CAMPAIGN BULLETIN

Seat Belt Buckle Bracket Dealer Inventory

Reference: PC849

PC849 - 2022 FRONTIER REAR SEAT BELT BRACKET BOLT

Figure 1

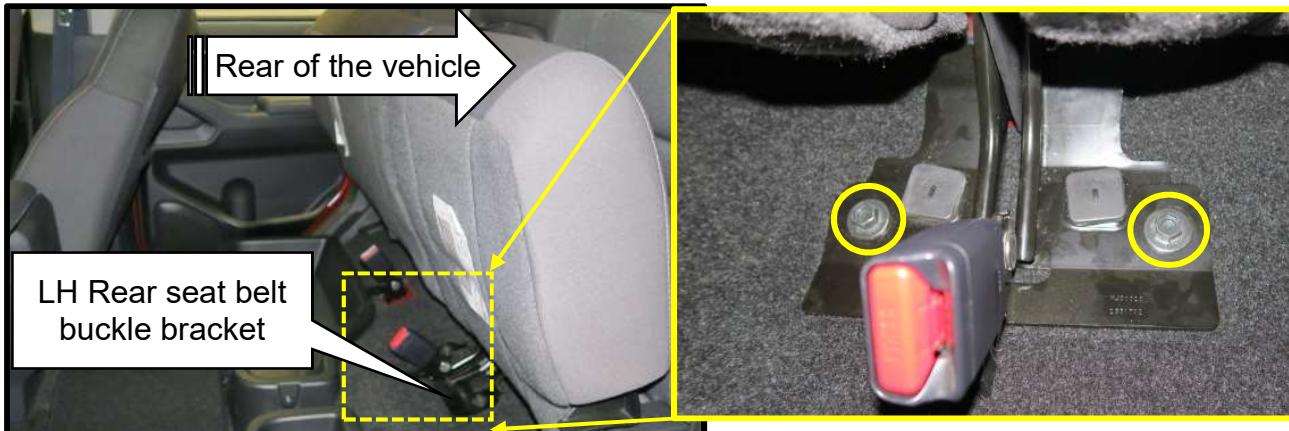
1. Lift both rear seat cushions to the upright position.
 - Open the rear doors
 - Pull the release handles and lift the seat cushions upward until they lock into place
2. Locate the LH rear seat belt buckle bracket bolts. (Figure 1)

Figure 2

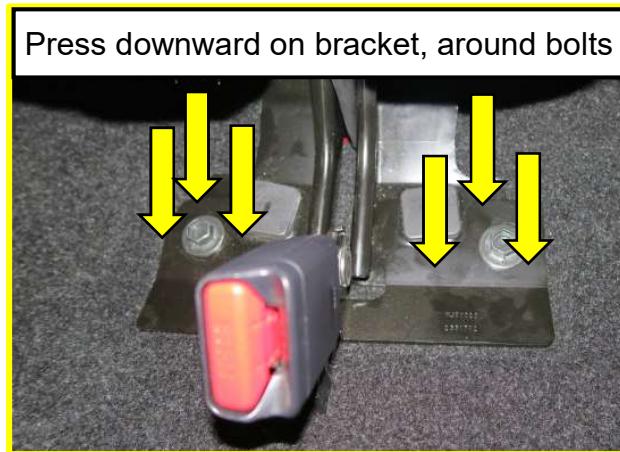
3. Following the three steps below, inspect both bolts that secure the LH rear seat belt buckle bracket to verify they are fully seated.
 - a) Verify the bolts are flush with the seat belt bracket, if either of the bolts are not flush with the bracket, the bolt is not fully seated
 - b) Attempt to turn the bolt washers by hand, if the washer turns, the bolt is not fully seated
 - c) Push downward on the seat belt buckle bracket around each bolt to check for bracket looseness, If the bracket has movement around the bolt, the bolt is not fully seated (Figure 2)
